# Obstacle Spot Checking OLS

**Session 2.2: Data Assessment & Analysis**  
**5 December 2017**

***AERODROME SAFEGUARDING WORKSHOP***  
***(Cairo, Egypt, 4-6 December 2017)***

*Presented by:*  
*Michelle Soliman, Aerodrome Ops Inspector*  
*General Civil Aviation Authority, United Arab Emirates*

**Obstacle ID: 3384**  
**Fujairah Tower**

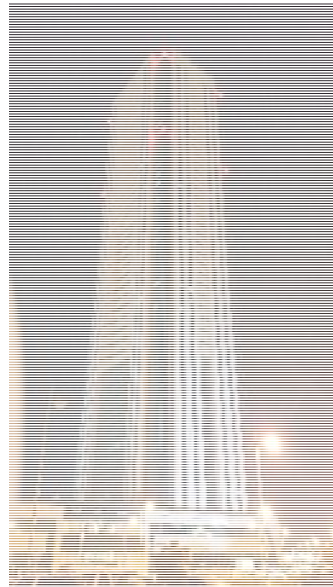
- Flights are not permitted over this area due to established city
- Lighting applied from “ground level” in consideration of surrounding structures
- High Intensity | Type A on top is not required – but no dazzle effect reported

*...in excess of regulation...*  
*No action required*

**Obstacle ID: 3291**  
**Millennium – Fujairah Mall**  
**(Fujairah Commercial Complex)**

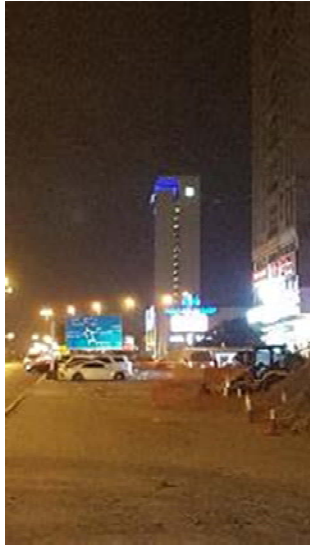
- Flights are not permitted over this area due to established city
- Lighting applied from “ground level” in consideration of surrounding structures
- Medium intensity Type A lighting on top of tower and medium intensity Type C on corners of mall structure

*...in excess of regulation...*  
*No action required*

**Obstacle ID: 4936**  
**Flag Pole**

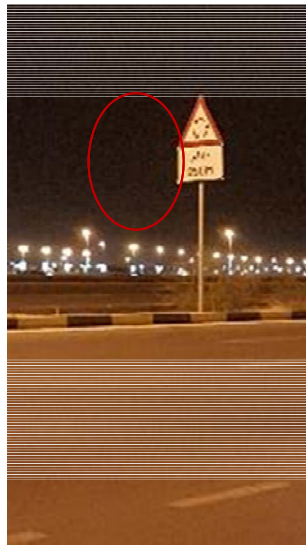
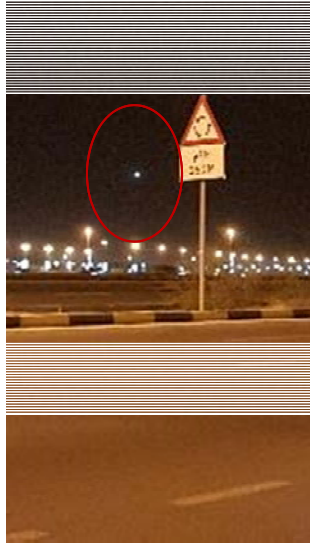
- High intensity lighting on top of flag pole
- Marking not required

**Assessment:**  
**Compliant**  
*No action required*

**Obstacle ID: 1203**  
**Du Comms Tower – Dibba Road**

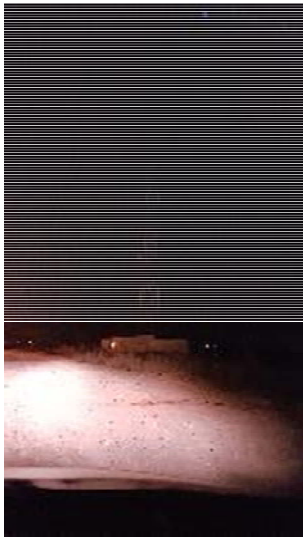
- Lighting was not serviceable
- Marking observed

**Assessment:**  
**Not Compliant**  
*Action: Contact Du and  
arrange for necessary  
maintenance*

**Obstacle ID: 2032**  
**Comms Tower – RAK Bank**

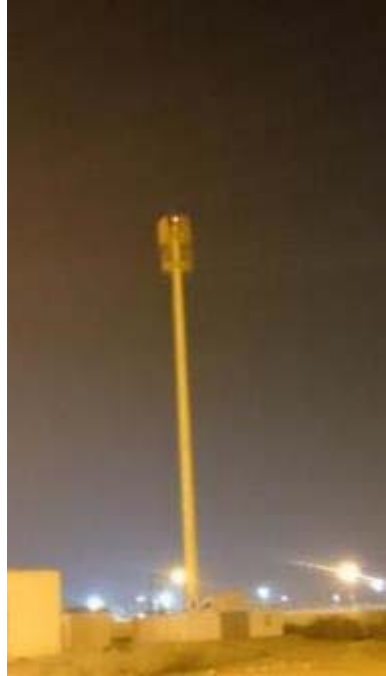
- Lighting observed
- No marking is observed

**Assessment:**  
**Compliant**  
*Action: Review  
requirement for marking*
